# UNITED STATES PATENT AND TRADEMARK OFFICE

APPLICATION NO.	FILING DATE	FIRST NAMED INVENTOR	ATTORNEY DOCKET NO.	CONFIRMATION NO.
10/558,840	12/16/2005	Alexander Zernickel	INA-17	8368

<b>Office Action Summary</b>	<b>Application No.</b> 10/558,840	<b>Applicant(s)</b> ZERNICKEL, ALEXANDER	
	<b>Examiner</b> Greg Binda	<b>Art Unit</b> 3679

Continuation of Attachment(s) 6). Other: Annotated Drawing from US 4,634,296.

FIG. 3

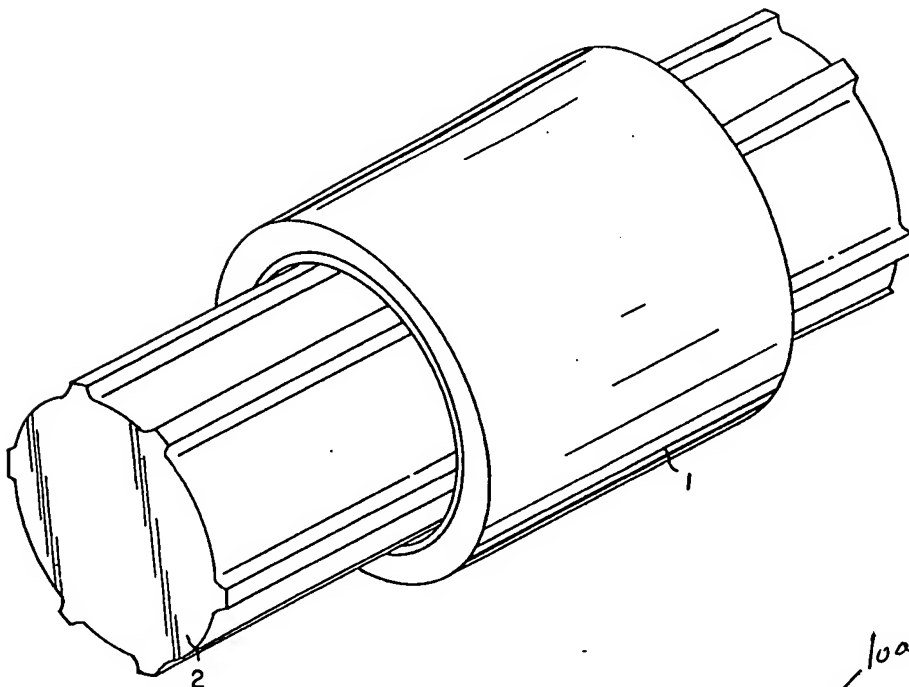
14. Claims 1-19 are rejected under 35 U.S.C. 102(b) as being anticipated by Watanabe, US 4,634,296. Figs. 3-8 show a linear rolling bearing for transmitting torques about its longitudinal axis, having an inner profile element 2 and an outer profile element/hollow body 1 which surrounds the inner profile element at least partially, the two profile elements being mounted via rolling bodies 3 such that they can be displaced with respect to one another in the longitudinal direction, which rolling bodies circulate endlessly in at least one first circulatory channel (see attached annotated drawing) and in at least one second circulatory channel (see attached annotated drawing), the circulatory channel having a loadbearing channel 4b (see attached

annotated drawing) which is parallel to the longitudinal axis, a return channel 4c which is parallel to the longitudinal axis, and two deflection channels 4c which connect the loadbearing channel 4b and the return channel 4a to one another in an endless manner, the rolling bodies which are arranged in the loadbearing channel of the first circulatory channel being provided for transmitting a torque in the **clockwise direction** between the two profile elements, and the rolling bodies (3) which are arranged in the loadbearing channel of the second circulatory channel being provided to transmit a torque in the **counterclockwise direction** between the two profile elements.

Figs. 4 & 7 show the rolling bodies 3 are arranged with play in the return channels 4a and without play in the loadbearing channels 4b.
